D5.6 Xerox® AltaLink® Product Enhancement Document for Version 114.xxx.032.20720

Description of new features and enhancements to the products specified below.

Release Date: August 10,2022

Product Model	System Software	Network Controller
AltaLink C8170	114.011.032.20720	114.011.20720
AltaLink C8145/55	114.010.032.20720	114.010.20720
AltaLink C8130/35	114.009.032.20720	114.009.20720
AltaLink B8145/B8155	114.013.032.20720	114.013.20720
Altalink B8170	114.014.032.20720	114.014.20720

3. Prevention of SW Downgrade with certain versions of Single Board Controllers

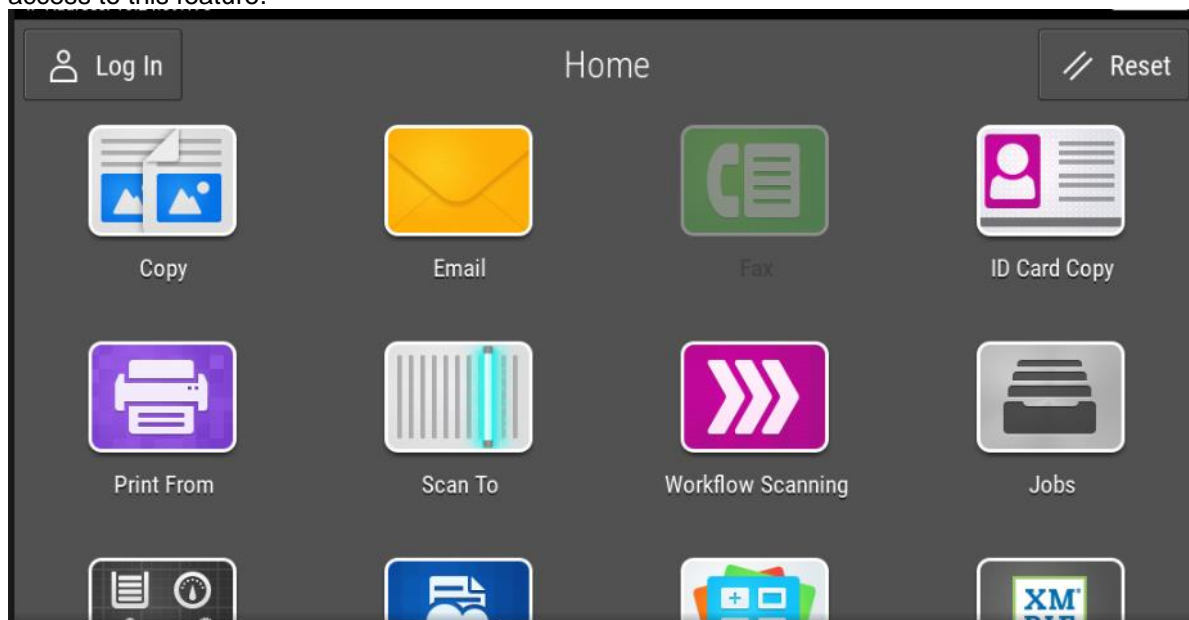
4. Support for the new Single Board Controller (SBC) components.

- Due to the world-wide issue of part shortages, alternate electronic components were required for the single board controller. From the beginning of year 2022, newly manufactured devices will have this new SBC and it will be introduced into spares inventory. The SBC will have Tag 3 checked on its tag matrix to the left of the board.

2. Enhanced Preview Capabilities

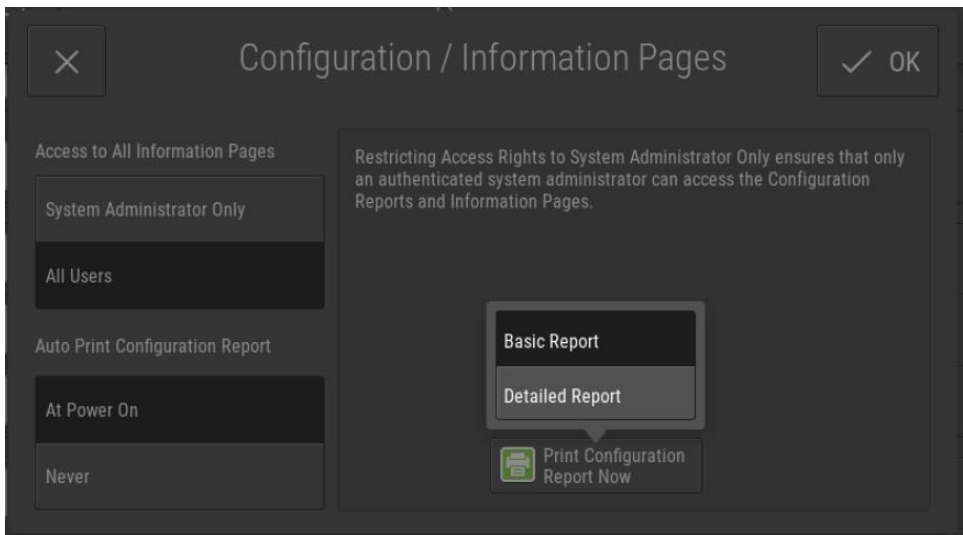
Introduces new preview capabilities to the native preview feature for Scan To and Scan to Email. Preview now supports the ability to delete images, re-order images and to change scan settings between scan segments.

The Scan API has been updated to allow EIP apps to take advantage of the native preview feature.

4. Detailed Configuration Report

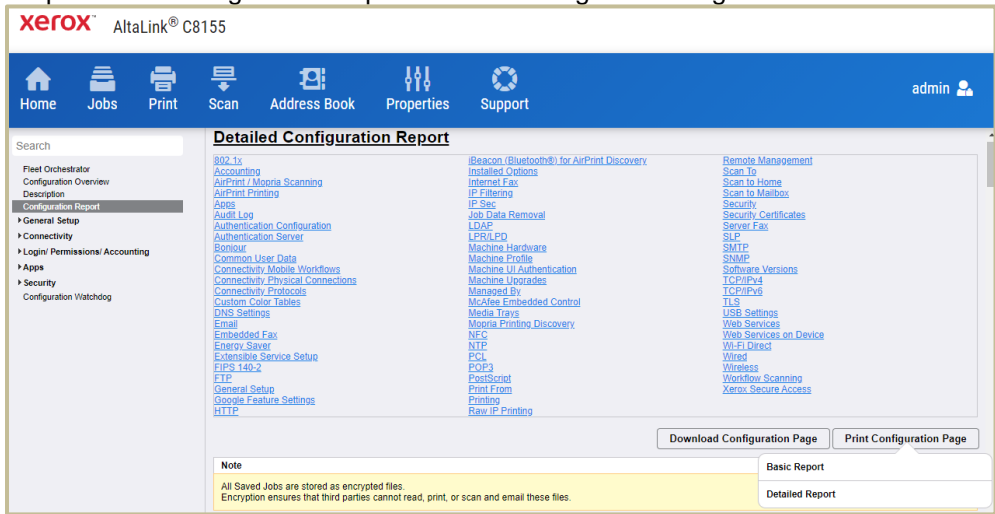
Introduces new Configuration Report options of Basic and Detailed. Both versions of the report can be printed by the Admin or guest user if access is configured. The Configuration Reports are accessible through the EWS and Local UI.

From the LUI, the Admin can configure the device to control access to the Basic and Detailed configuration reports. (Device App -> Tools -> Configuration / Information Pages). Printing of the reports is also available by selecting "Print Configuration Report Now" & selecting the Basic or Detailed Report.

Printing of the configuration reports from EWS:
 Properties -> Configuration Report -> Print Configuration Page -> Select the Basic or Detailed Report

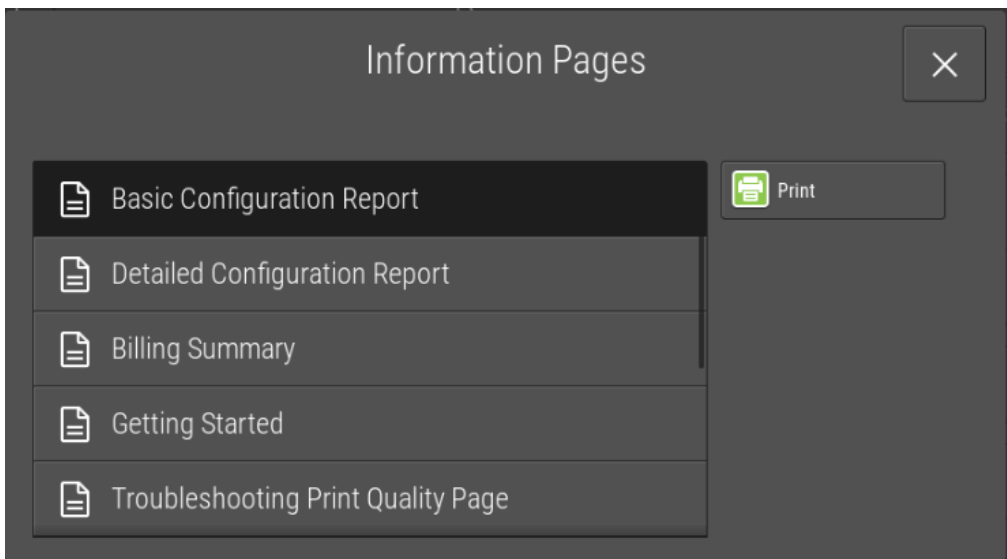
Printing of the configuration reports from the LUI:
 Select Device App -> Information Pages -> Select Basic or Detailed Configuration Report -> Print
